Attachment 5 - Design Review Advisory Panel

Table 5.1 details the advice provided by the Shellharbour Design Review Advisory Panel during its consideration of the development and how the applicant has responded to these comments through design changes. The ground floor plan considered by the Design Review Advisory Panel is included below.

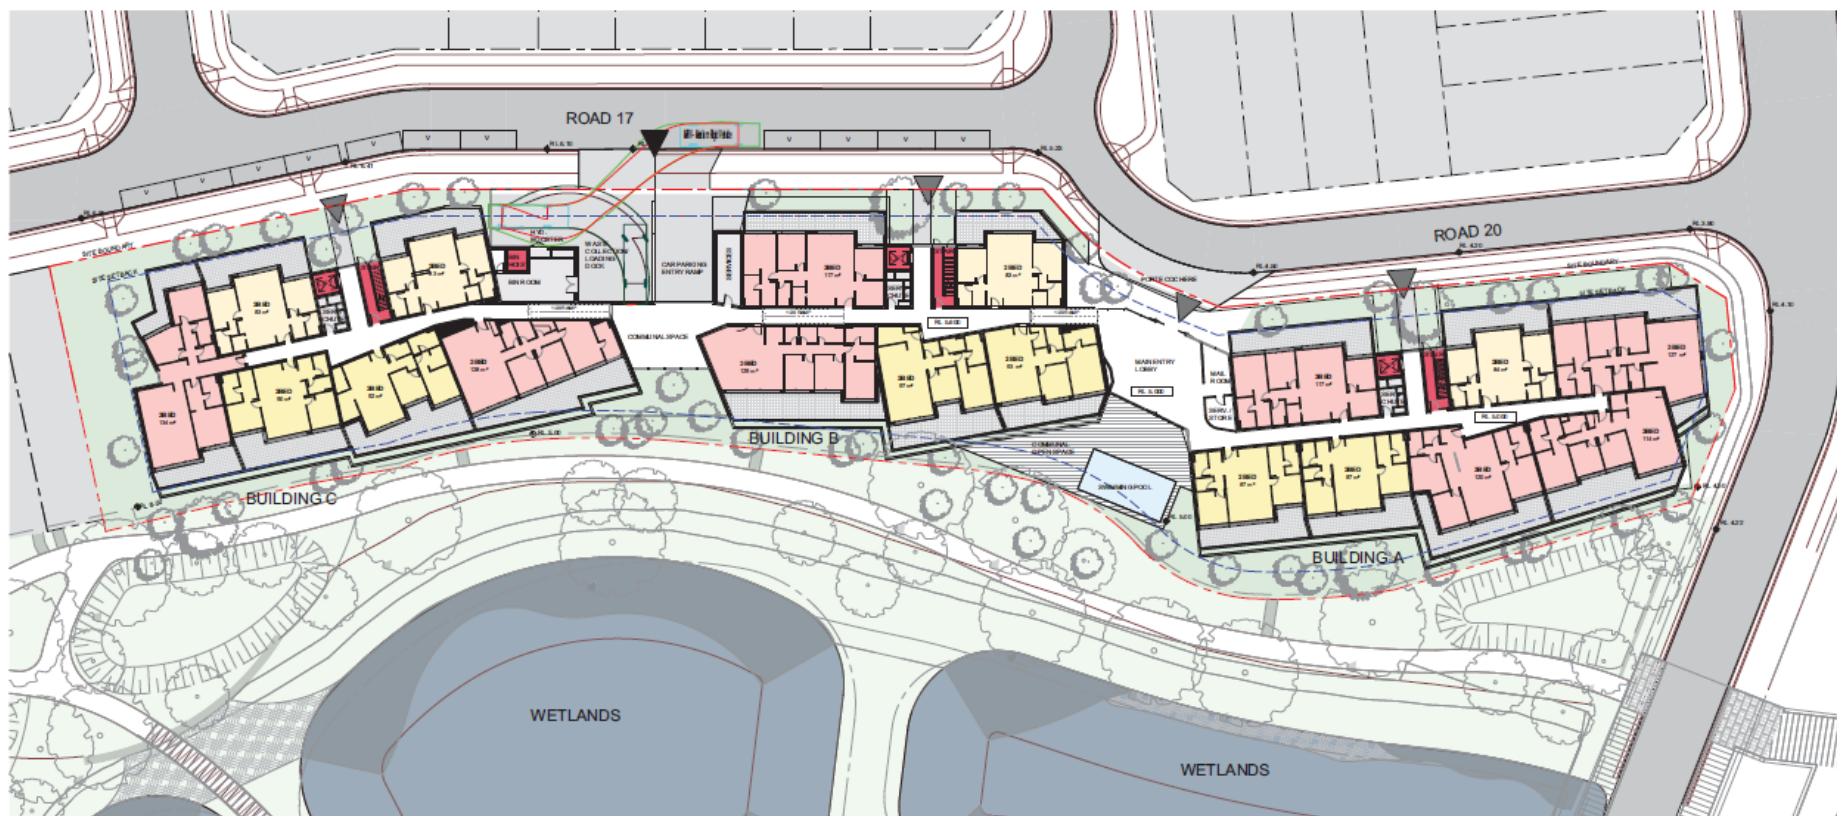
The main amendments from the proposal that was considered by the Design Review Advisory Panel is the reduction of the number of apartments (from 74 to 64), separation of the three buildings at ground floor level, the increase in setbacks of each building and the amendment to the vehicle access to the site.

The joining of buildings at ground level removes physical and visual permeability through the site.	The design was developed prior to DA lodgement and the buildings are not connected at ground level (refer Figure 1). The proposed development allows views from the Cormorant Way and Lapwing Avenue public domain south through the site towards the wetlands. In addition, a public through site link is provided along the boundary adjacent to Building C's western facade.	The three buildings proposed will have adequate separation providing physical and visual permeability though the site.
